# URBAN DESIGN REPORT

**SITE PLAN CONTROL**

**SUBJECT SITE: 116-118 CARRUTHERS AVENUE**

**REPORT DATE: NOVEMBER 15, 2024**

Figure 5: 3D renderings of proposed development showing surrounding existing planned context (Source: Redline Architecture)

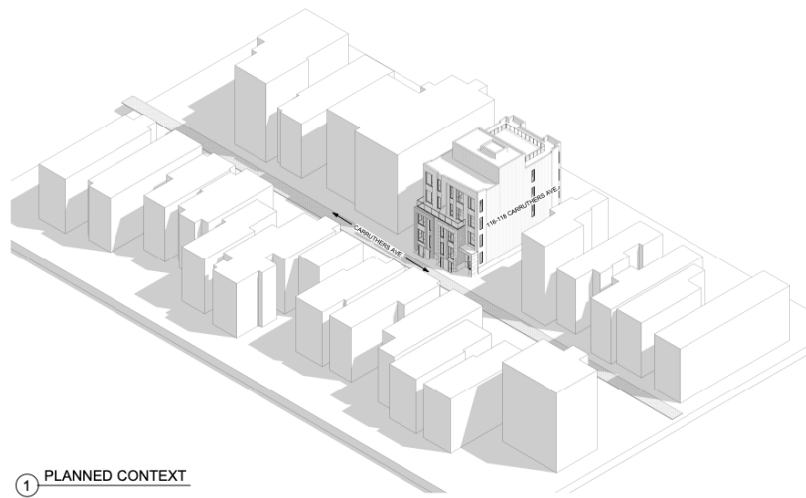
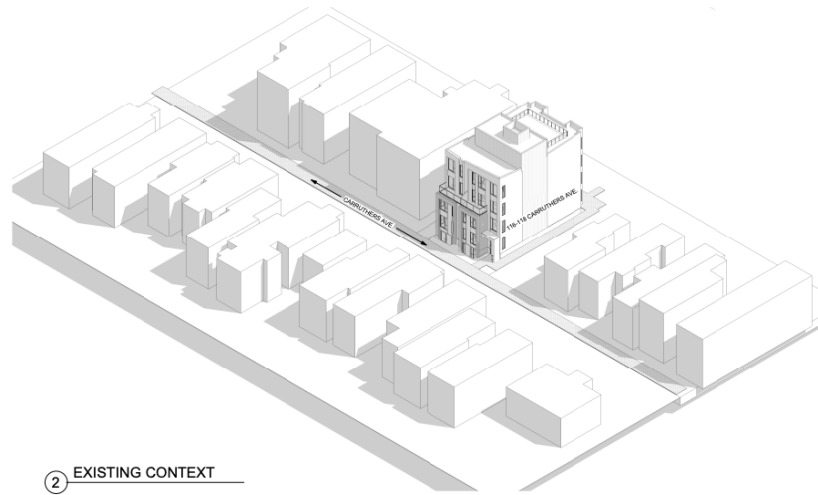
We recommend providing the built form planned context in the 3D modelling illustrations to help analyze the scale of the proposal in its context. This can be ghosted blocks on the neighbouring properties.

Please see the existing and planned context 3D models in Section 4.0 Design Research of this report.
